Colin Leach – Mulberry Well Systems L.L.C.
Comment on BSEE Proposed Rule for Offshore Drilling

[Docket ID: BSEE-2015-0002; 15XE1700DX EEEE500000 EX1SF0000.DAQ000]

**Oil and Gas and Sulphur Operations in the Outer Continental Shelf—Blowout
Preventer Systems and Well Control**

Fig 1 – Macondo Drill Pipe Pressure Record Showing Evidence of Well Shut-in

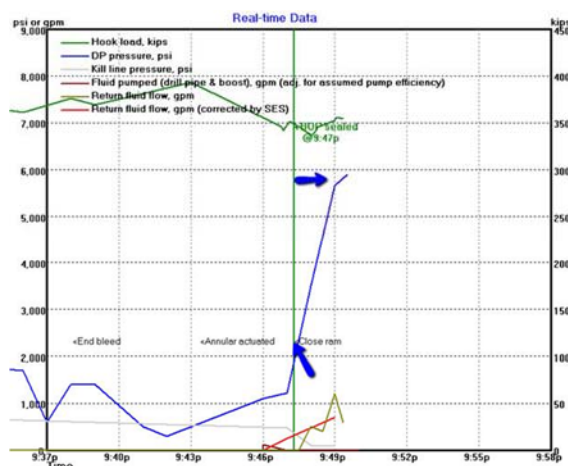
Real-time data evidence from Macondo (CSB report). Starting at 9:47pm, the drill pipe pressure rocketed up from ~1,000 psi to nearly 6,000 psig at ~9:50 pm, when transmission was lost due to the explosion. That high DP pressure can only be explained by a BOP (VBR) sealing. i.e. the well was shut-in at the BOP prior to the explosion

Fig. 2 – Well Barrier Diagram (www.WellBarrier.com)

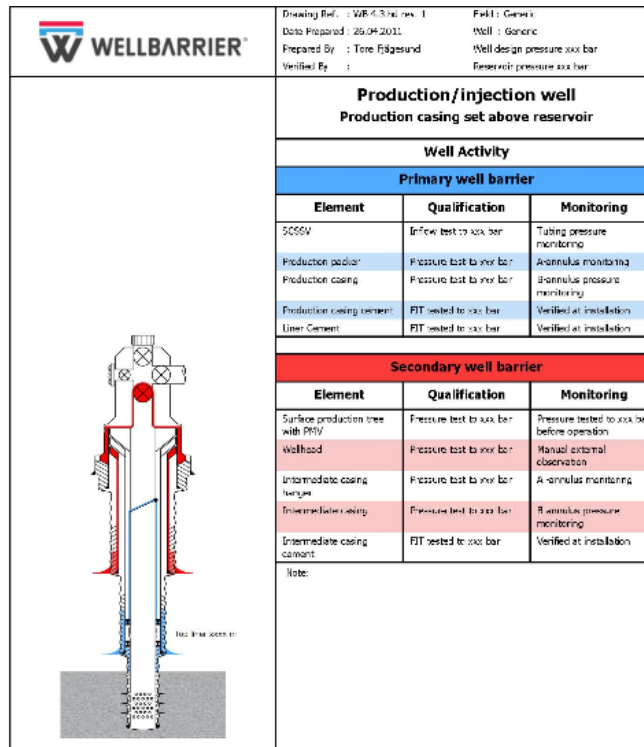
2. More focus on the barrier system
 - a. A comprehensive (up to date) barrier diagram for each well (Norsok D-010 provides a framework of what can be achieved – **something similar is suggested**), showing the condition and verification of each component of the barrier system is suggested. This diagram must be a central pillar – available for all involved to see and available for inspection by authorities without notice. An example from WellBarrier (www.wellbarrier.com) is given below. It allows the identification of each component of the barrier and the condition/verification of each of these components to be articulated.

Fig 3. Example of Choices for Selection of Mud Weights – Small Drilling Operations Window

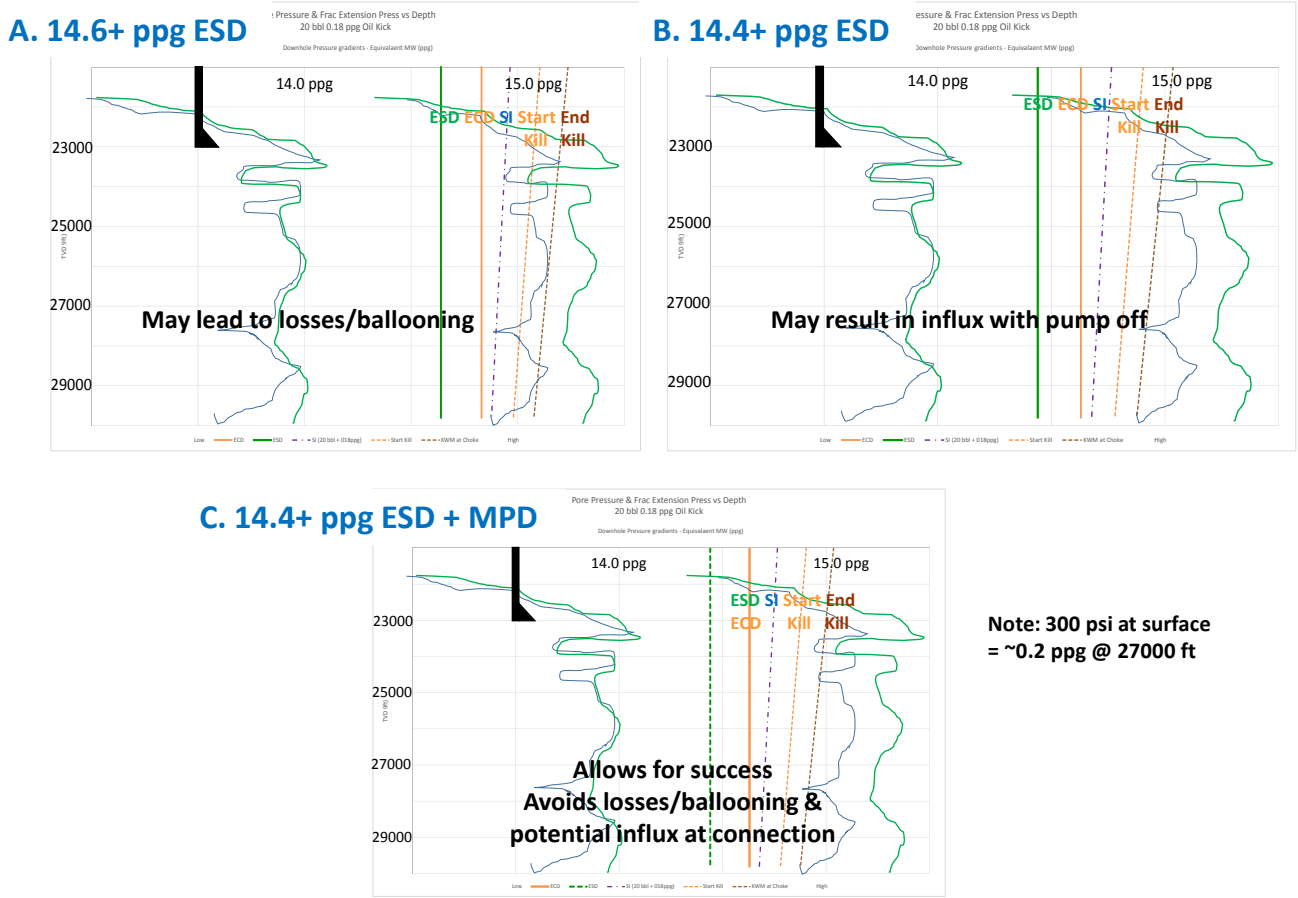
- The proposed rule § 250.413 & § 250.414 should be combined and amended. There should be no mandatory “one-half pound per gallon below the lesser of the casing shoe pressure integrity....”. This in itself may lead to unsafe (or less safe) practices as an operator decides to maintain a lower mud weight than prudent in order to satisfy the rule leading to a higher potential for an influx. An alternative is discussed below:

The proposed rule includes **§ 250.414 para (2)**. In the above example, it is clear that Choice A provides less than the “required 0.5ppg margin”. However (and for the estimated pore pressure and fracture gradient) it is clear that Choice A reduces the probability of an influx occurring.

By contrast Choice B follows the proposed rule but increases the potential for an influx.

In comparing Choice A and Choice B and given that the best estimate of pore pressure (including uncertainty) is the same in both cases, it is obvious that Choice A provides less potential for an influx.

If a pore pressure exists which has the potential to cause an influx in Choice A, and the same pressure influx were taken following Choice B, then the potential for losses would be essentially the same in both cases. The only merit to choosing Choice B is that it might provide more “warning” of a pore pressure increase due to increasing gas levels, but this method of pore pressure detection is only a part of the detection process at this time (it used to be the primary method of pore pressure assessment).

Choice C introduces the potential use of active MPD (Managed Pressure Drilling). (it could be argued that Choices A & B are essentially MPD, but without the “active” equipment)

The goal of this proposed suggestion is to allow the operator to make a sensible (yet appropriate) choice, rather than forcing a solution which may well result in a less safe choice. It also allows for uncertainties in estimations to be articulated and it allows for the magnitude of a “target” influx to be established (target kick tolerance).
